SIAMESE PONDS WILDERNESS AND JESSUP RIVER WILD FOREST

Amendments

2005 Siamese Ponds Wilderness Unit Management Plan

2006 Jessup River Wild Forest Unit Management Plan

Figure 3. Proposed Wakely Brook Trail in Siamese Ponds Wilderness

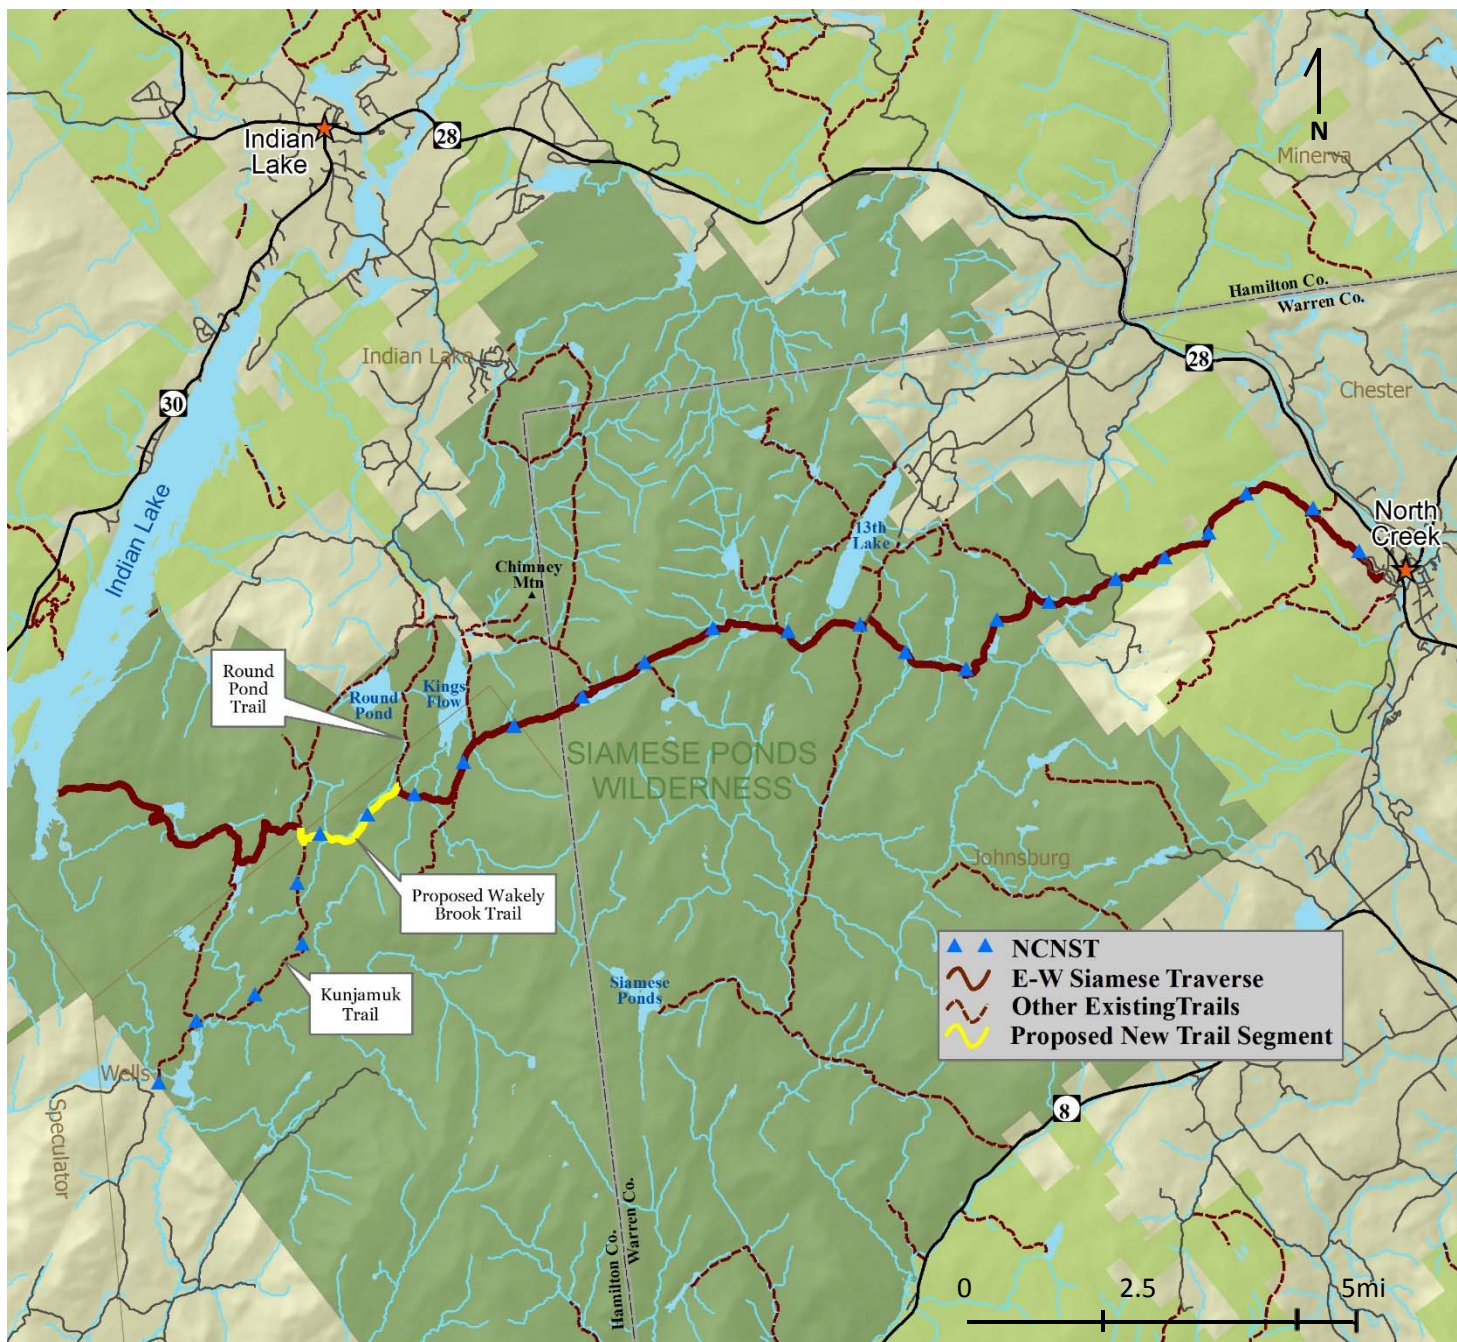
The Department proposes to construct a trail between 1 ½ and two miles in length connecting the Kunjamuk Trail with the Round Pond Trail along Wakely Brook. This trail connection would complete a 24 mile east to west stretch of existing trails that would allow the public to traverse the entire unit from the Ski Bowl in North Creek to the shores of Indian Lake. This segment is proposed to be a section of the NCNST through the Siamese Ponds Wilderness (see Figure 3.) The majority of the NCNST route through the Wilderness Area would rely on existing trails. The only gap is between the Kunjamuk Trail and the Round Pond Trail, where the NCNST Plan proposes this new connecting trail segment. This proposal also meets an objective of the Great South Woods plan. After conducting preliminary field work, Department staff have confirmed that a suitable trail could be located in this area.

Comment: In terms of the Wakely Brook Trail, where is the analysis of its role as part of the North Country National Scenic Trail and the potential impacts to the natural resources and visitor experience?

Response: *The location and potential impacts of the proposed Wakely Brook Trail were identified in the North Country National Scenic Trail Adirondack Park Trail Plan/Environmental Impact Statement, released by the Department in 2015. The Wakely Brook Trail will greatly improve the connectivity of the trails in this unit with nearby adjacent units and communities. As part of the NCNST it is the key link in getting from Elm Lake Road in Speculator to North Creek. As part of the NCNST, the Department expects a fair amount of recreational pressure and will monitor trail*

Figure 4. Unmarked trails proposed to be marked

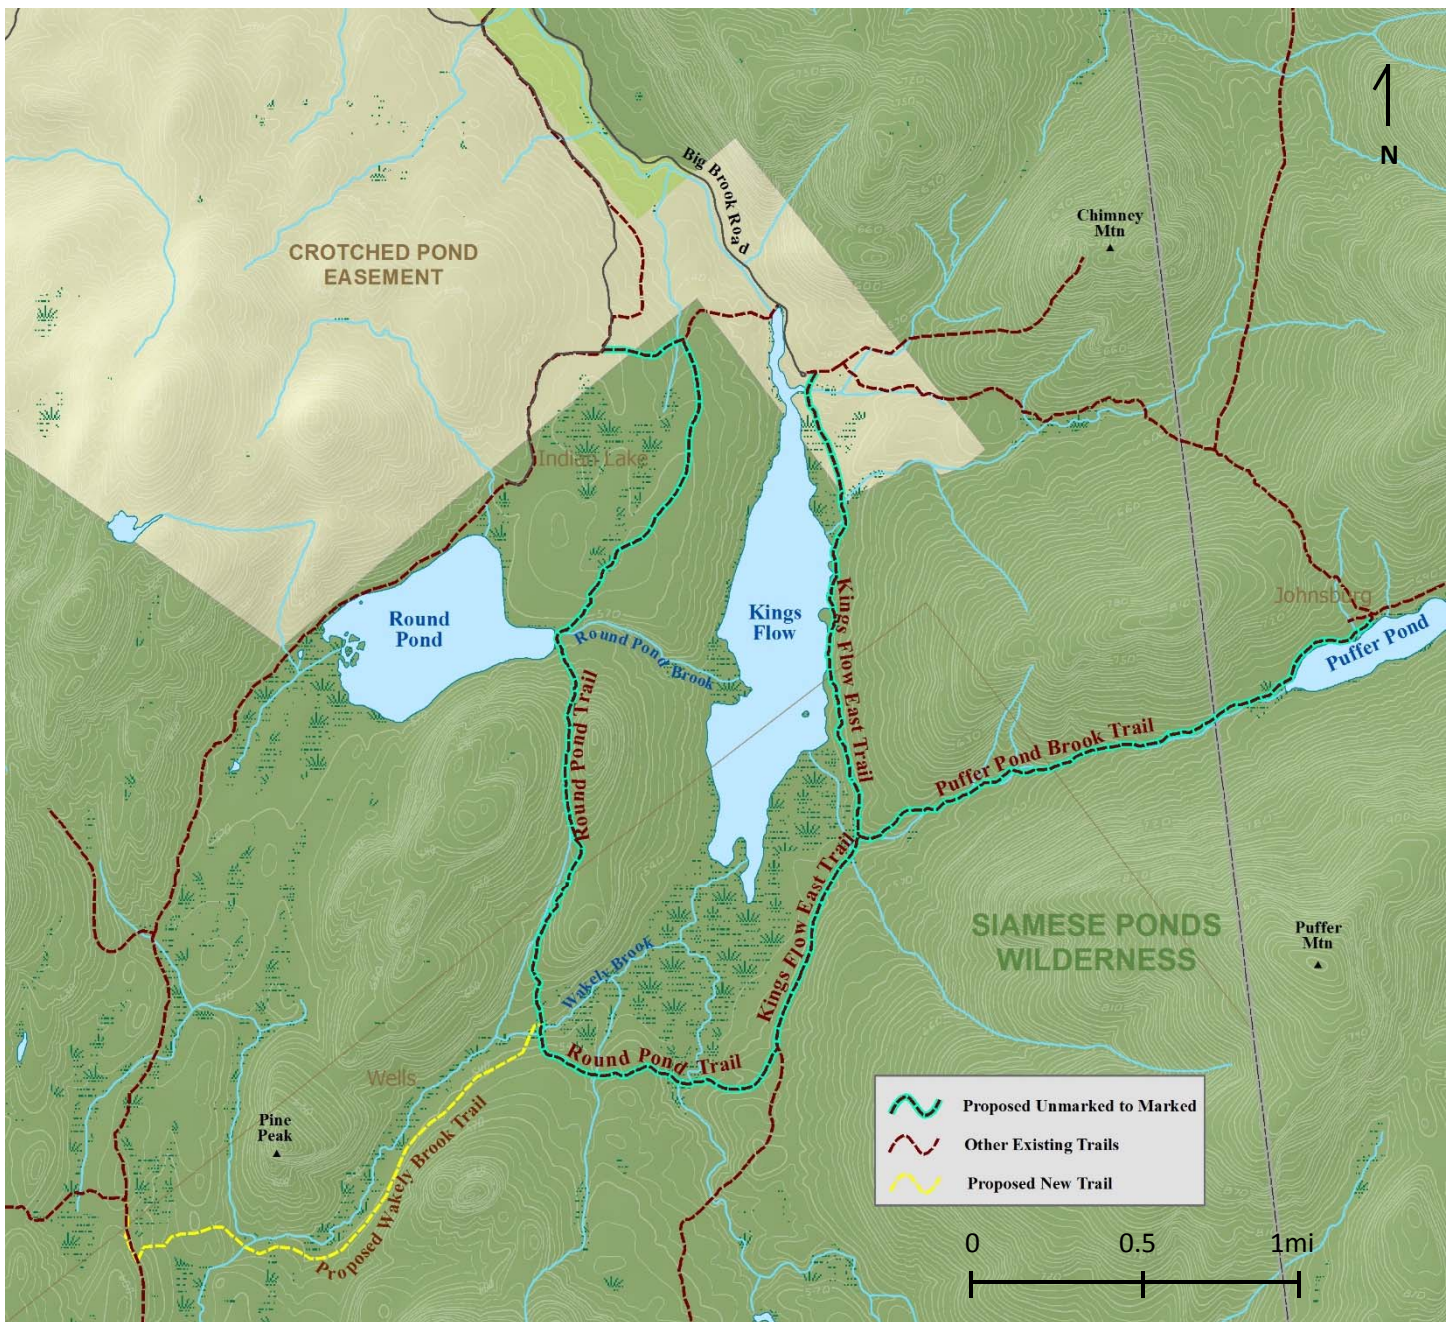
The Department proposes to officially designate and mark the Round Pond Trail, the Kings Flow East Trail, and the Puffer Pond Brook Trail (see figure 4). These trails are currently listed as unmarked in the Unit Management Plan, however they are well established on the ground and there is significant use by the public from the Chimney Mountain Trailhead. In order to make the trail system more clear in this area and in turn more safe, the Department is proposing to change the status of these trails to “marked” and maintain, sign and mark them in accordance with Department foot trail marking and maintenance guidance. Marking of the Round Pond Trail beyond Round Pond Brook is contingent on securing the rights to cross the Crotched Pond Conservation Easement to connect with the Kunjamuk Trail. Therefore, that section of the Round Pond Trail north of the brook will not be marked until that agreement is made.

Comment: Does the public have access to the unmarked trails that are proposed to be marked and whose trailhead originates on private land?

Response: *The public currently has access to these trails from Puffer Pond or by bushwhack from Kunjamuk trail. The trails are also currently accessed from private land to the north of King's Flow. The Department is in the process of developing a long-term cooperative agreement with the landowner to continue this access. These trails include Chimney Mountain Trail, West Puffer Pond Trail and the Kings Flow East Trail. The separate proposal in this UMP amendment to create the Wakely Brook Trail will also provide access from the south to these currently unmarked trails.*

Figure 5. Lean-to proposed to be retained

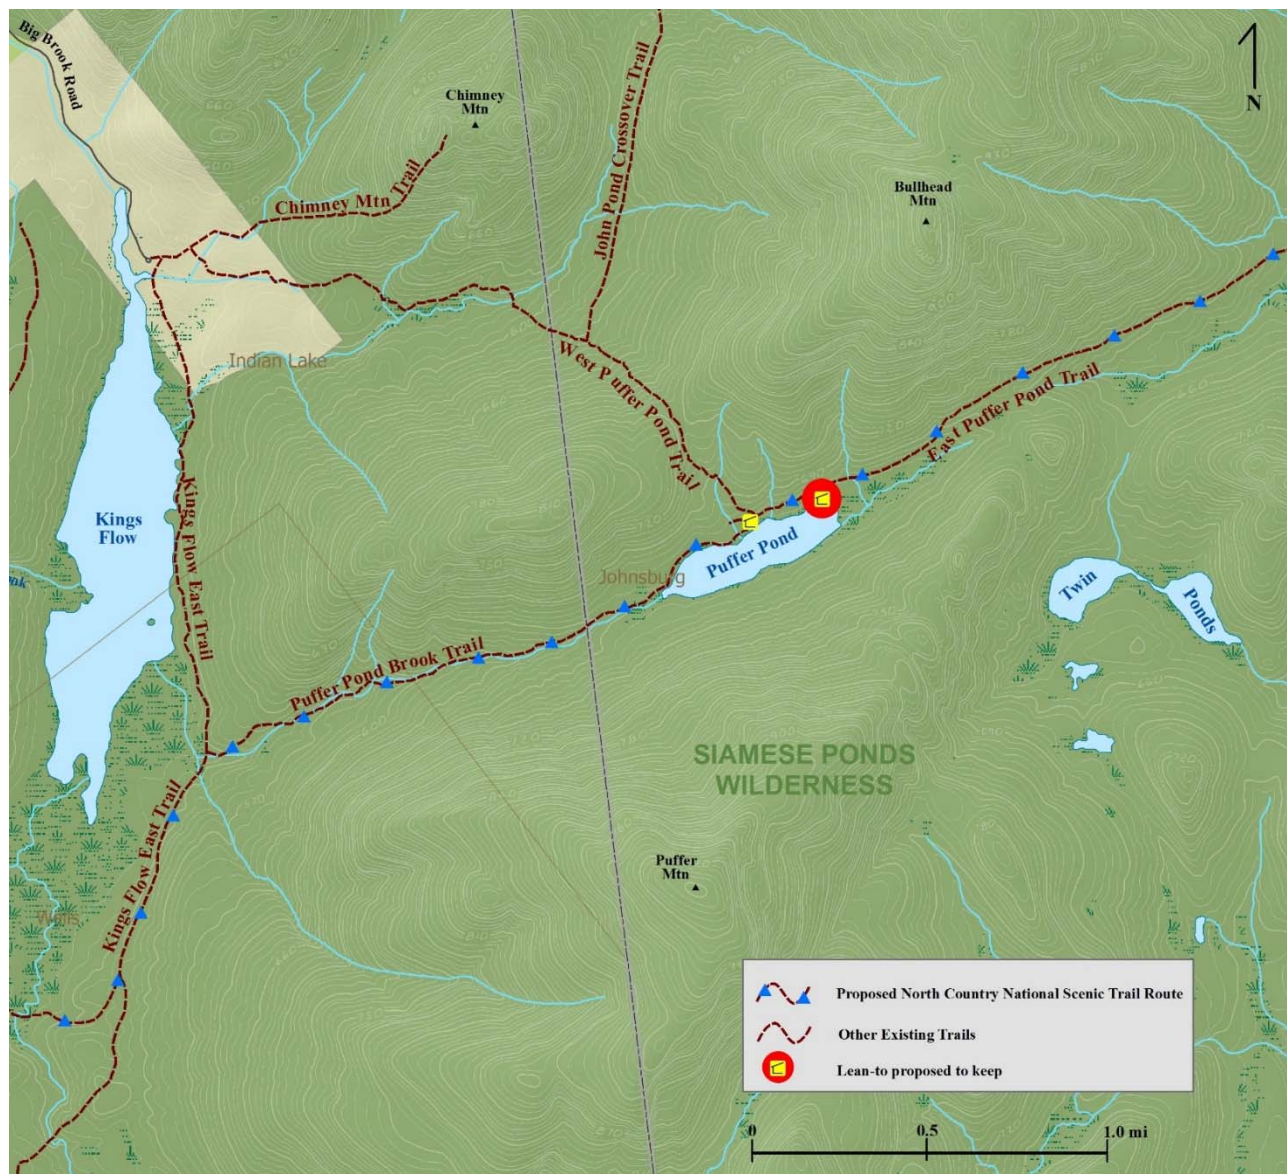
The Siamese Ponds Wilderness Unit Management Plan called for the eventual removal of the Puffer Pond lean-to on the eastern end of the pond. This location is a popular destination and while the UMP indicates siting and use issues, it has since been determined that if there were issues years ago, they are not apparent now. The location is desirable by many according to lean-to logs and user feedback and with the NCNST designation along the Puffer Pond Trails, maintaining both shelters would be beneficial for managing the additional use at the pond. Therefore the Department proposes to keep both lean-tos on Puffer Pond (see Figure 5). Repairs are needed and at the time those repairs are made, the eastern lean-to would be moved back and sited a minimum of 100 feet from mean high water mark.

Figure 6. Hut to hut connector trail

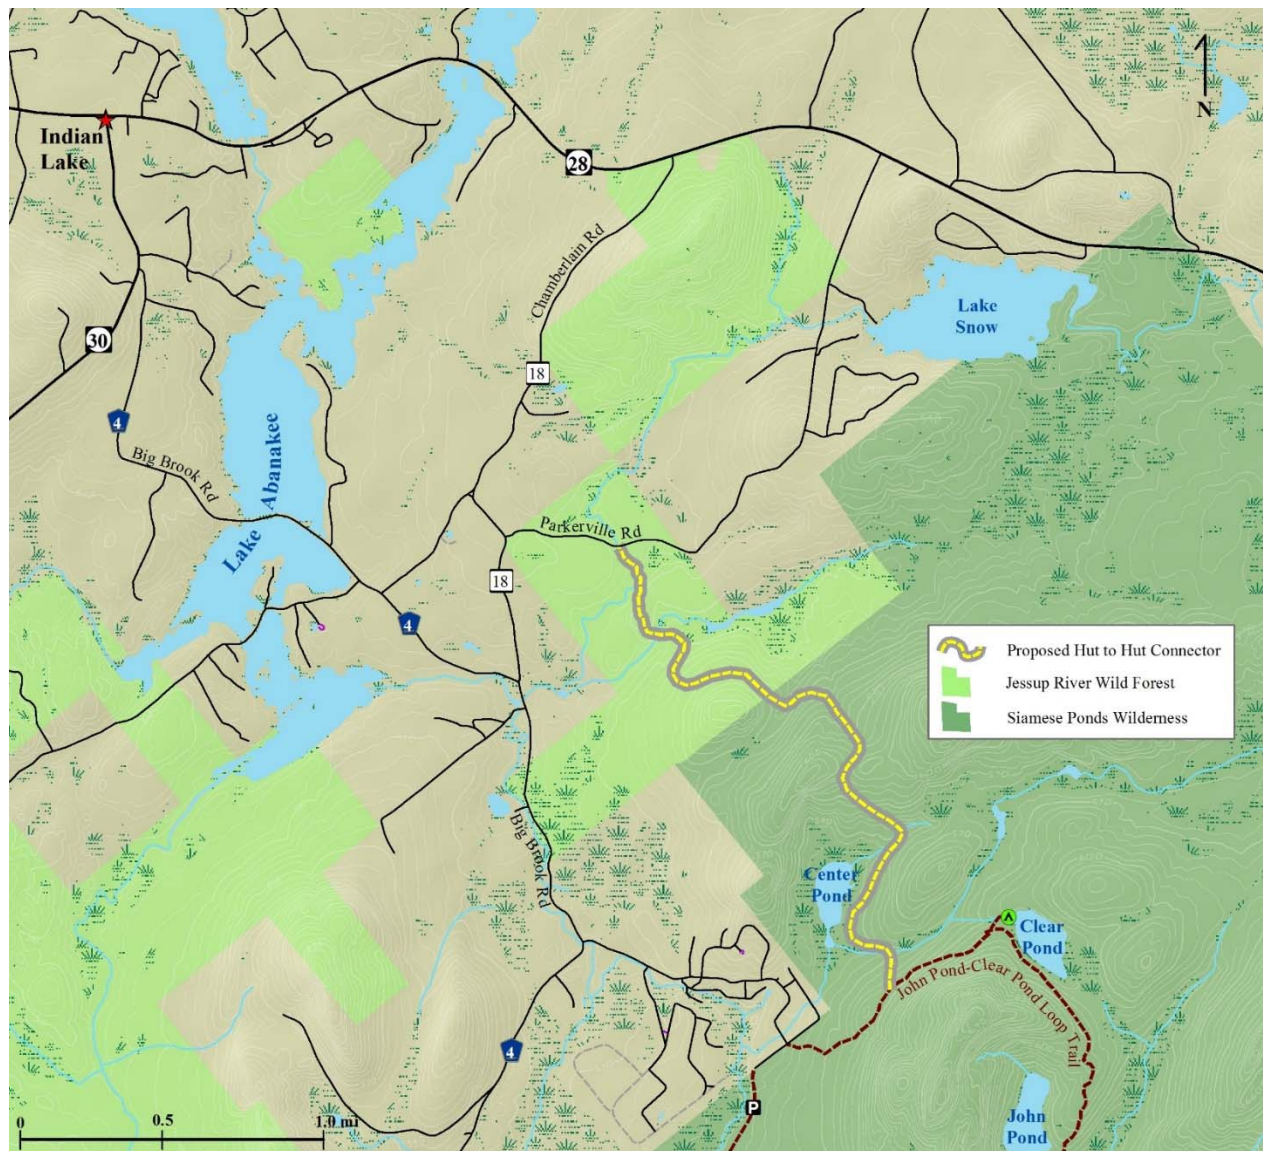
The Department proposes a new section of trail connecting with town roads leading to Indian Lake as proposed in the Hut-to-Hut plan. This section of trail would go from the John Pond - Clear Pond Loop Trail running northerly through Siamese Wilderness Area (approx. 1.6 miles) and an adjacent Jessup River Wild Forest parcel (approx. 1.0 mile) out to Parkerville Road in the Town of Indian Lake. Figure 6 shows a corridor of opportunity. Figure 7 shows the overview of connections to the communities of Indian Lake, North Creek and Speculator through Siamese Ponds Wilderness Area.

Comment: The proposed new trail from Clear Pond to Parkerville Road appears to be implementing a conceptual Hut-to-Hut plan that has not been subject to public comment or evaluated for compliance with the State Land Master Plan.

Comment: There is no demonstrated public demand for the proposed connector trail from Clear Pond to Parkerville Road and it should be dropped from the amendment.

Response: *Based on staff-level consultation with the Adirondack Park Agency (APA), Department staff believe the trail connection will comply with the Adirondack Park State Land Master Plan (APSLMP). Procedurally, the introduction of this project through a UMP amendment follows the Department's standard process for publicly vetting proposals on State land, including those that involve partners. The reference to the Hut-to-Hut Destination-based Trail System report merely provides context to better facilitate public understanding of the proposal. The Hut-to-Hut report, as a whole, is not being evaluated through this UMP amendment.*

Response: *The Department is committed to creating better, safer connections between local communities and State lands for long-distance thru hikers. This proposal will eliminate over 1.5 miles of road walking for those wishing to walk into the hamlet of Indian Lake.*

Figure 8. Approximate location of a Botheration Pond Trail re-route

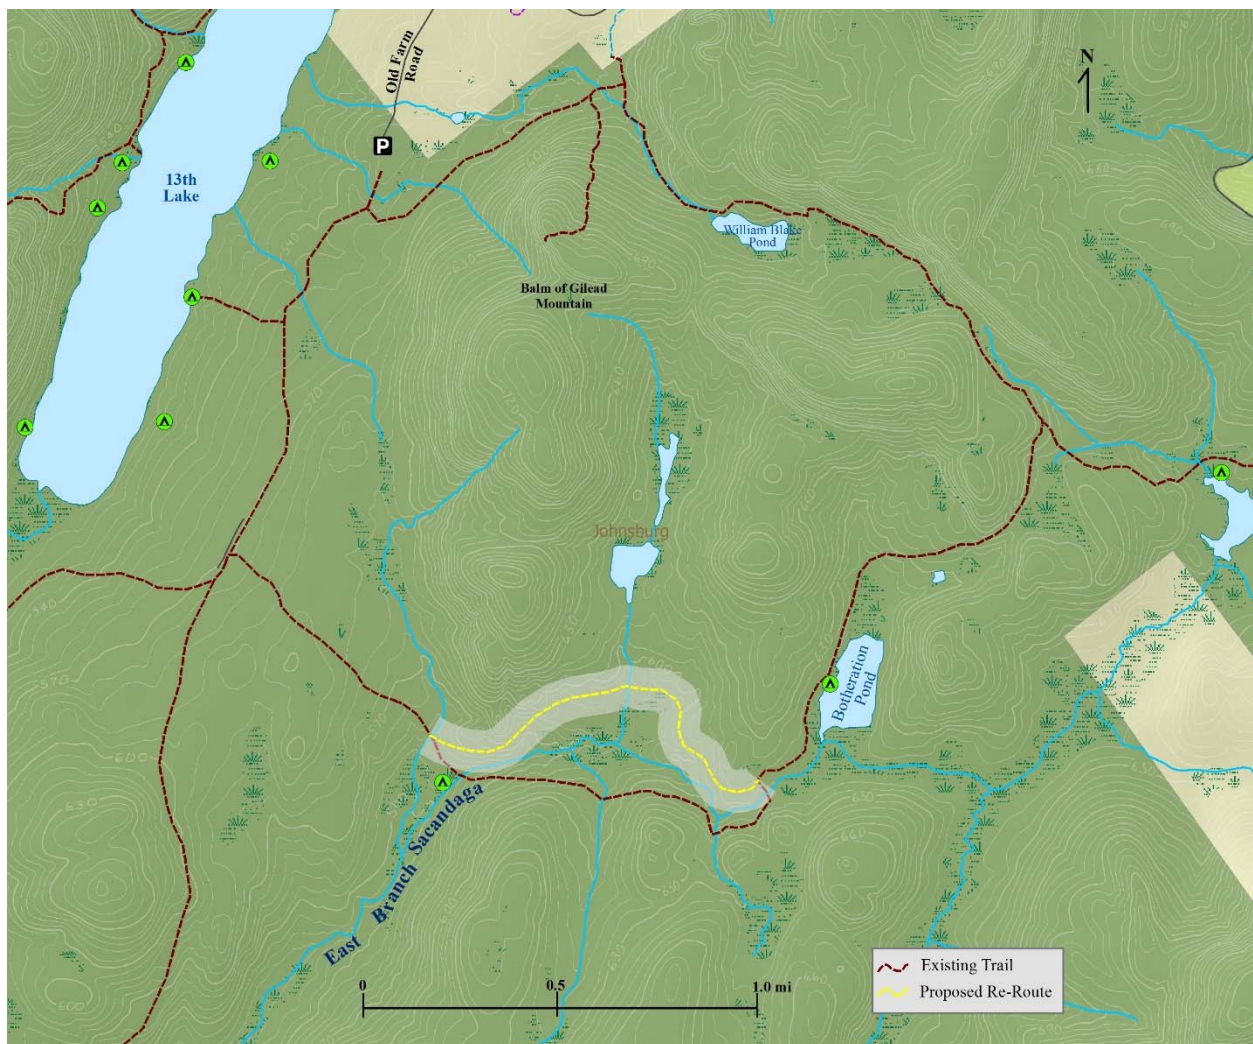
In the Siamese Ponds Wilderness, on the Botheration Pond Trail, the 55 foot bridge over the Sacandaga River has failed. This is a very popular trail with skiers and in most cases in the winter the river, which is shallow to bedrock in this section, is frozen solid, creating an ice bridge, even in the recent milder winters. In the summer/fall the river can usually be crossed using rocks and bedrock ledges. The Department proposes to maintain the trail in its current location without replacing the bridge. The Department will monitor the river banks at this location for erosion and evaluate safety conditions of this crossing on a regular basis. If at any point in the future it is determined that the lack of a bridge at this location is not acceptable – for natural resource protection or safety concerns – either a bridge will be constructed or the trail will be re-routed to avoid this river crossing entirely (see Figure 8).

Comment: Where the bridge went out on the Botheration Pond Trail, can there be a third alternative that would keep the trail in place (i.e. no re-route) and simply does not replace the bridge, resulting in a ford/stepping stone crossing at the old bridge location?

Response: *This is a very popular trail with skiers and in most cases the river, which is shallow to bedrock in this section, is frozen solid, creating an ice bridge, even in the recent milder winters. In the summer/fall the river can be crossed using rocks and bedrock ledges. This option would be consistent with Wilderness recommendations in the SLMP to minimize the use of manmade structures. The preferred alternative has been amended to reflect this option but the Department plans to monitor the river banks at this location for erosion and evaluate safety conditions of this crossing on a regular basis. If at any point in the future it is determined that the lack of a bridge is not acceptable—for natural resource protection or safety concerns—either a bridge will be constructed or the trail will be re-routed to avoid the need for a bridge.*
